GOVERNMENT OF THE DISTRICT OF COLUMBIA
OFFICE OF PLANNING

SUBJECT: Final Report, Zoning Commission Case No.03-12G and 03-13G
- Application by Capper/Carrollsborg Venture LLC and the District of Columbia Housing Authority (DCHA)
- Request for Approval of 2nd Stage Hope VI PUD for Squares 882 and 769

DATE: March 9, 2009

Figure 2: PUD Plan and Status

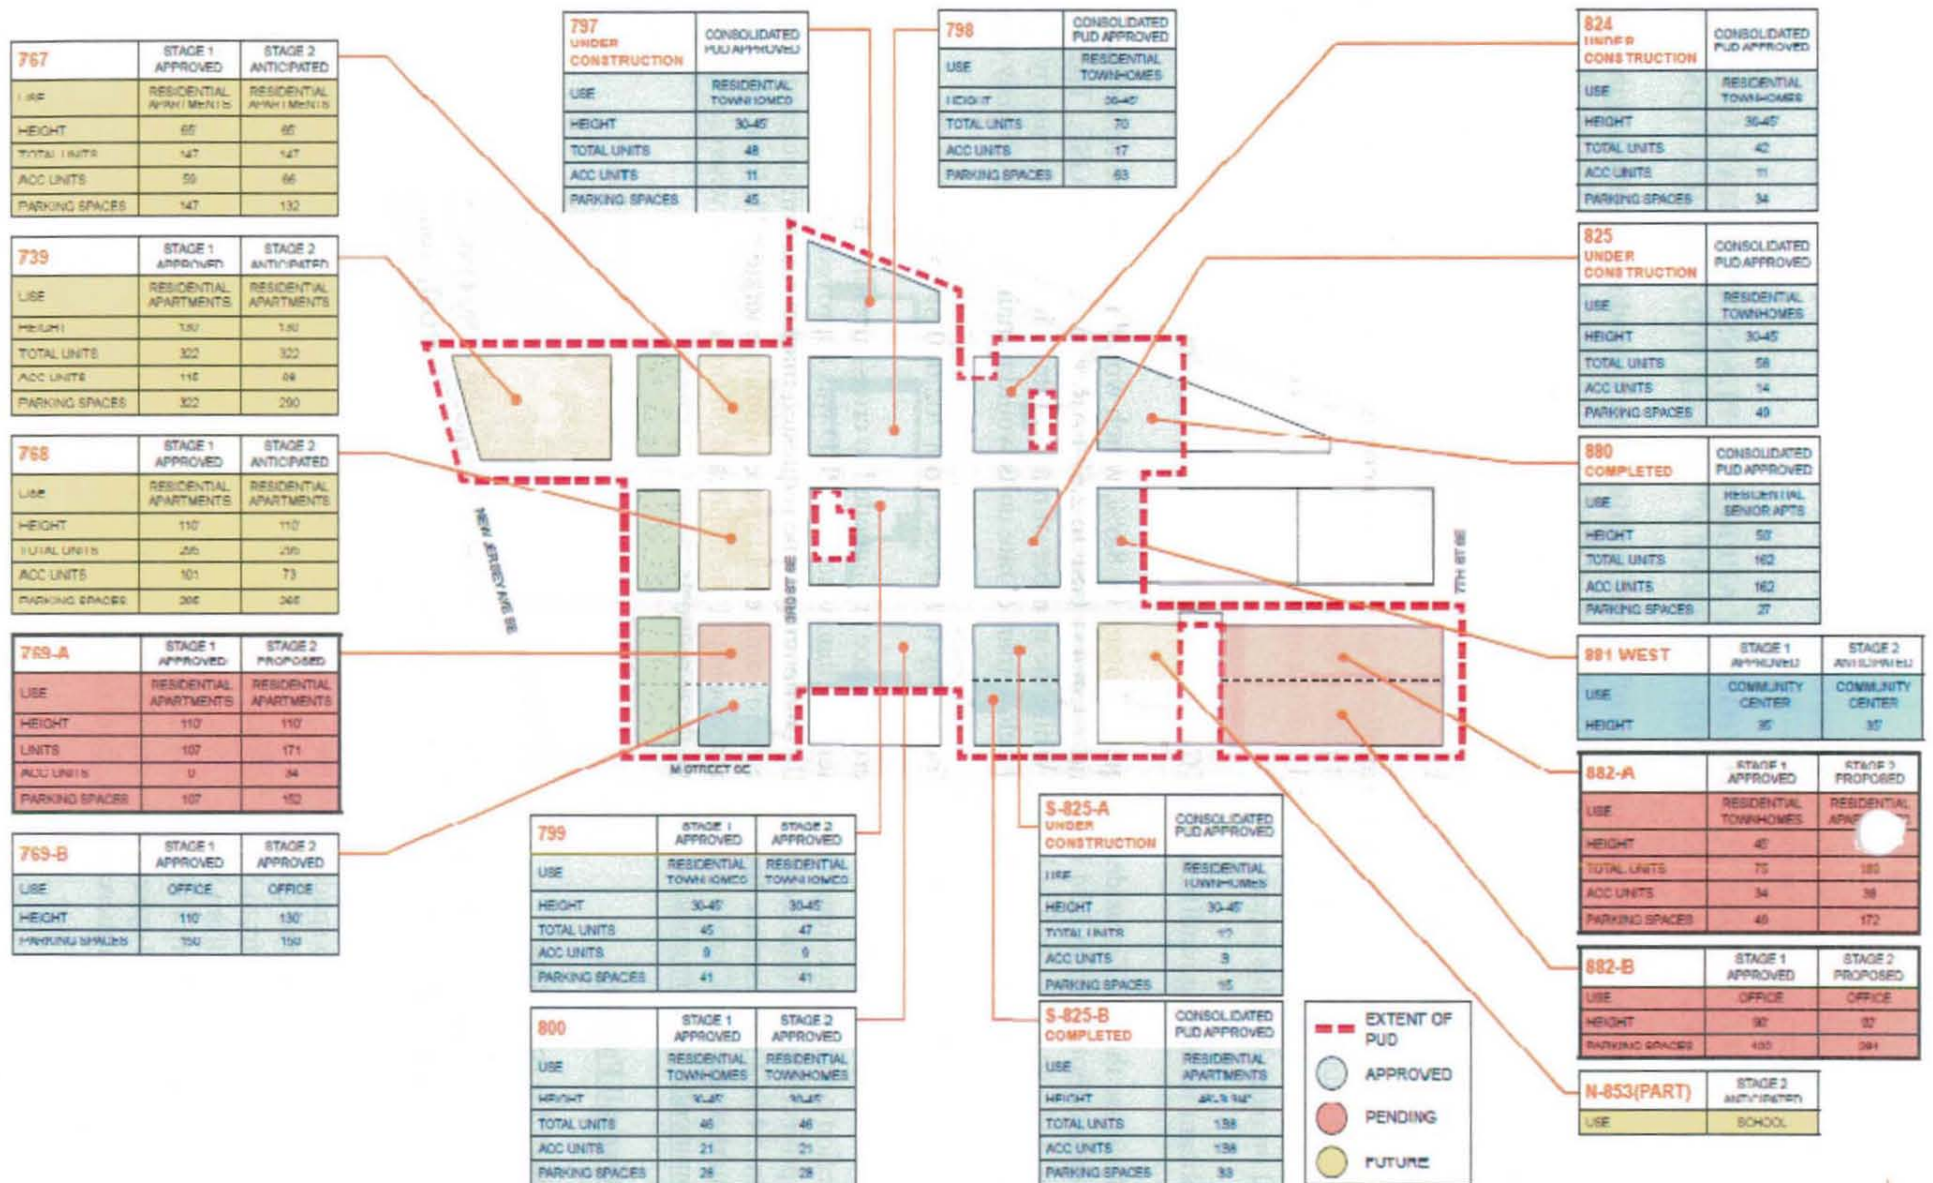
¹ The PUD boundaries shown on the Applicant's Dec. 1, 2008 Sheet 1.3 are correct. Those on the Sheet 1.1 aerial photograph are not.

- Account for what seem to be minor discrepancies between the requested overall net parking reductions and the total of the individual changes shown on Sheet 1.3 of the December 1, 2008 drawings.
- Be prepared to discuss these reductions at the public hearing in the context of a fully built-out Capper-Carrollsborg development, including the supply of on-street parking. The Gorove/Slade Associates parking study included in Section E of the application addresses parking for the residential building in Square 825 S only in the context of the current occupancy of that building and the existing nearby development. It suggests that some of the building's parking needs may be satisfied through on-street parking.

Figure 3: Square 882 Proposals

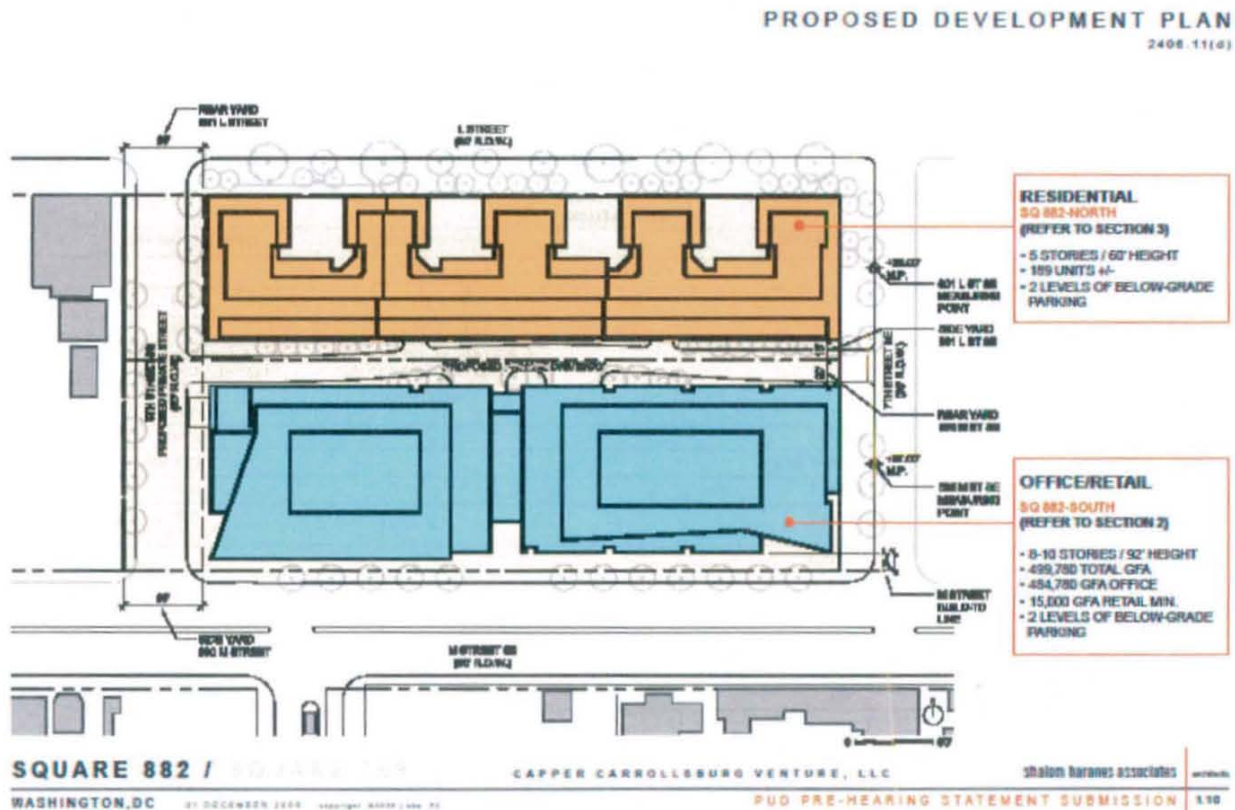
The office building would be two feet (2.2%) higher and 3,780 square feet (1%) larger than was approved in Order No. 03-12 / 03-13. It would contain at least 15,000 square feet of ground floor retail space and approximately 484,000 square feet of office space. It would have frontage on three sides and share a private alley with the residential development to the north. Loading would be off the alley. Parking would be accessed from the private 6th Street on the west and from the eastern side of the private alley behind the building. The building's mass would be broken into a nine story eastern wing and a ten story western wing with a three story retail, service and office section between the two sections. The roofline of the two wings would be at the same elevation point, but the number of stories would vary due to the grade's falling from east to west.

GSF: The requested 3,780 GSF increase would allow the applicant to give more shape to the building's mass without having to reduce the approved square footage. The revised design is less blocky and is more dynamic than the previous design. OP recommends the approval of the Second Stage square footage increase.

OP recommends approval of the requested 2' height increase.

Figure 4. Location of Proposed Apartment Building

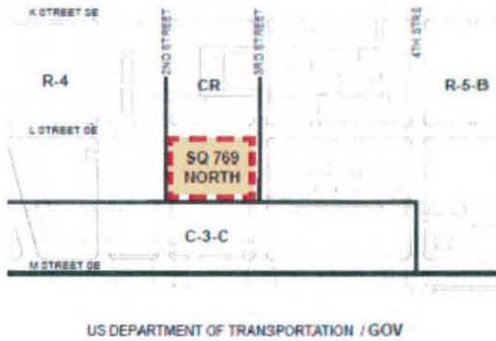
The residential building on the northern half of Square 769 would be 11,514 square feet larger and have 64 more units than previously approved. The increase number is due partially to its becoming rental units rather than the previously contemplated condominiums. The application proposes a 110 foot tall multi-family building with 177,330 GSF of residential space and 4,090 GSF of retail space. There would be 171 units, of which 20% (34) would be reserved for households earning no more than 60% of the AMI. All units would have access to 7,600 GSF of amenity space.

The Second Stage design has eliminated a proposed 3rd Street curb cut for secondary parking access, in response to reservations expressed by DDOT.
